GUNSTFONTEIN WIND ENERGY FACILITY AMENDMENT APPLICATION BAT IMPACT ASSESSMENT

May 2019

Arcus Consultancy Services South Africa (Pty) Limited

Plate 1: Examples of bat buffers (yellow rings) of aquatic features. The pink polygons are NFEPA wetlands according to the 2011 NFEPA database. On the left, the buffer is approximately 50 m from the wetland edge instead of 200 m. On the right, some NFEPA wetlands have not been buffered.

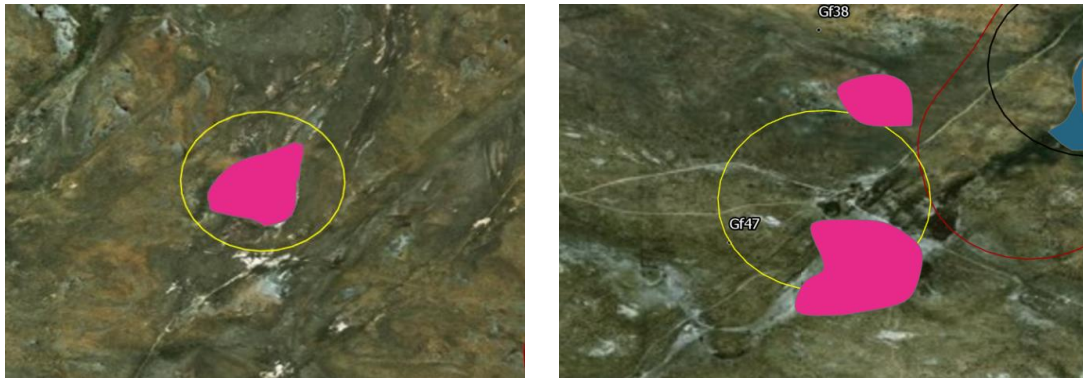
It is unclear which aquatic GIS dataset(s) Bioinsight used for the buffers. There are several instances where it appears as if the buffer distance were measured from the centre of the aquatic feature, and not the edge which is best practise, or available data were not used (Plate 1). This results in the current buffers providing inadequate protection against potential impacts as a smaller area than required has been buffered. Arcus have re-created the sensitivity map using the National Geo-Spatial Information Topographic dataset (2015), and the National Freshwater Ecosystems Priority Areas database (2011). The updated sensitivity map (Figure 1) shows that several turbines border the bat buffers and their blades may intrude across bat sensitive areas, depending on the final turbine specifications. The Mitchell-Jones and Carlin equation must be used to adjust the positioning of these turbines to the appropriate distance, during the design phase.

Bat Sensitivity Map
Figure 01

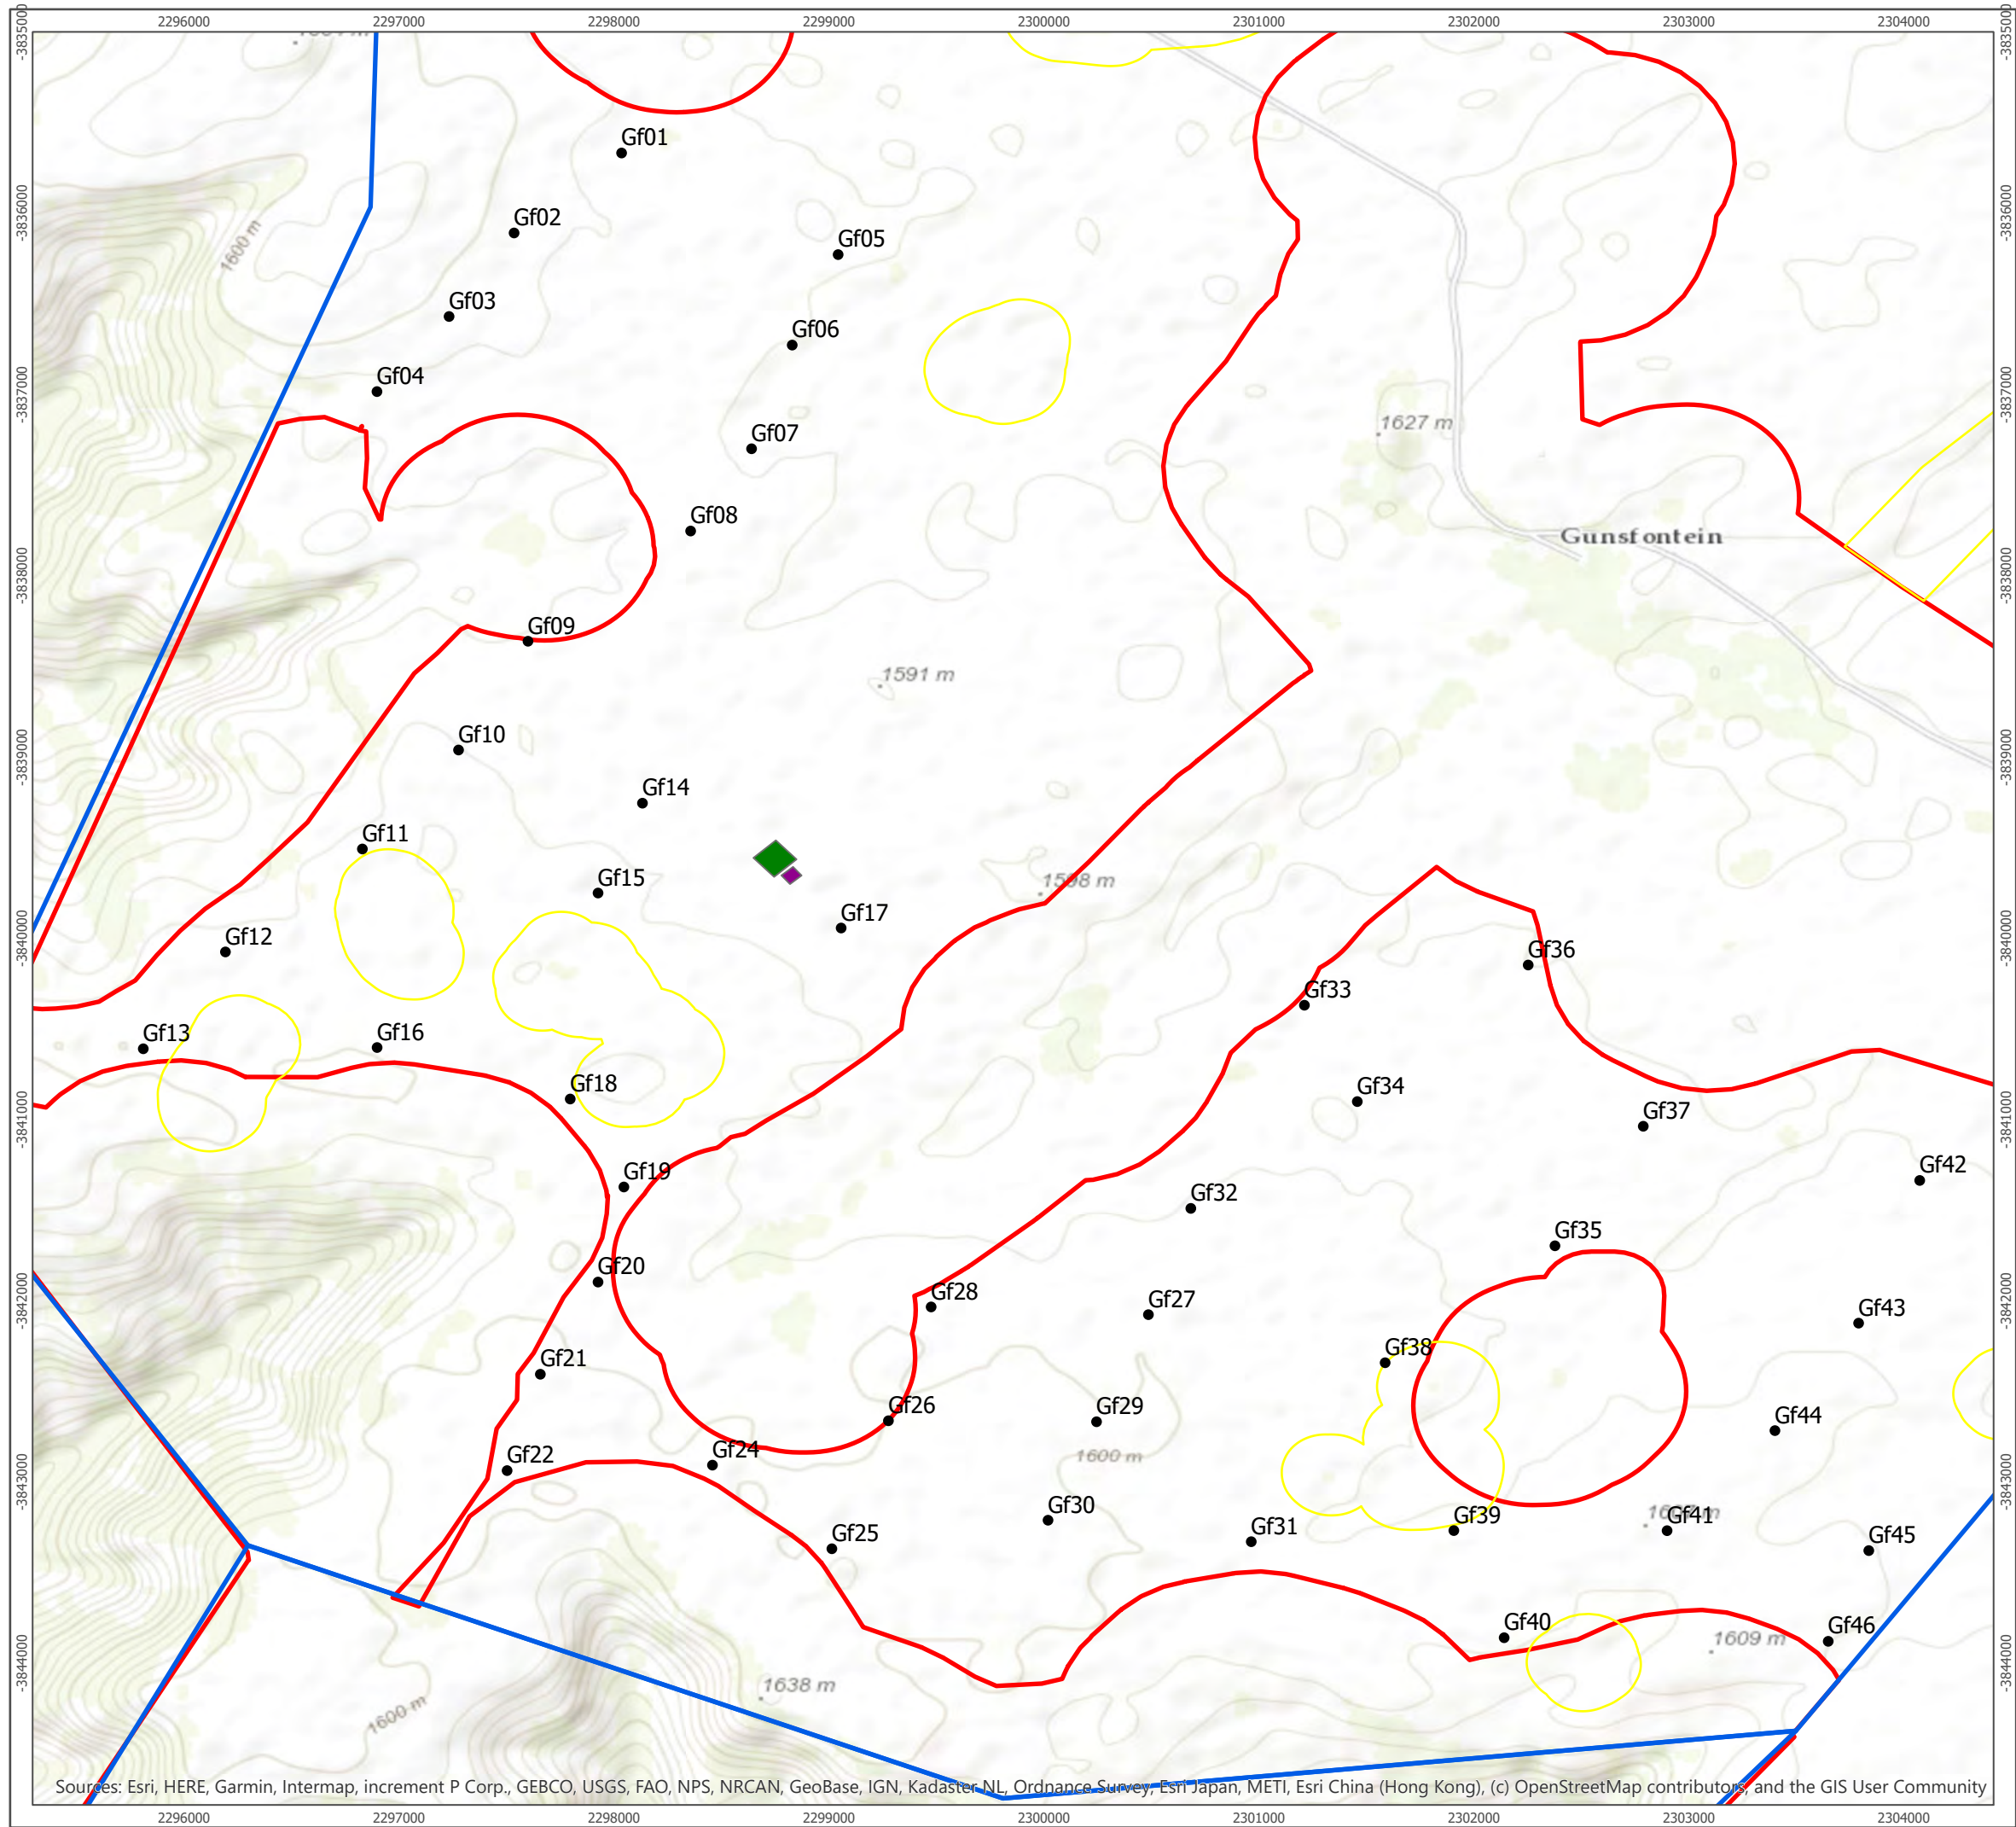
Can impacts be mitigated?	Yes		Yes	
Mitigation: Mitigation measures <ul style="list-style-type: none"> All currently proposed mitigation measures proposed by Bioinsight (2015), Savannah (2016) and in the EA should be adhered to. This includes adhering to the updated sensitivity map (Figure 1) which may require repositioning turbines if their blades will intrude into these buffers. These buffers are regarded as no-go areas for turbines only, and other infrastructure (roads, cables etc) are permissible. A bat specialist must map the final turbine layout before micro-siting and assess whether all turbines are appropriately sited such that their blades do not intrude into bat buffers. All mitigation measures to protect bats proposed in the EMPr (Savannah 2016) must be adhered to. Additional mitigation measures <ul style="list-style-type: none"> The impacts presented can be mitigated by using turbines which maximise the ground clearance as much as possible, and by minimising the tip height (i.e. the distance between the ground and the blade tip at its highest point). <p>To be included in the EA: a minimum buffer to blade tip for all bat buffer zones is required (buffer distances are on page 66 of Bioinsight 2015, and mapped in Figure 1).</p>

The key initial mitigation measure that should be implemented at the Gunstfontein WEF would be adherence to the updated sensitivity map (Figure 1). The exact combination of turbine dimensions that will be selected is unknown but depending on the size of the turbines selected, several turbines will need to be micro-sited to prevent the blade tips intruding into bat buffers as several turbines border bat sensitive areas (Figure 1). The final layout (which includes revised turbine positions and an additional access road) will therefore need to be assessed by a bat specialist to ensure this is adhered to once the turbines are chosen. This can be done during the pre-construction specialist walk-through and micro-siting process and must include the specialist mapping the final layout and determining if all turbine blades are outside bat buffers. Any turbine micro-siting will need to be done before construction. Residual impacts that occur will need to be evaluated during the operation phase using carcass searches to monitor actual impacts.
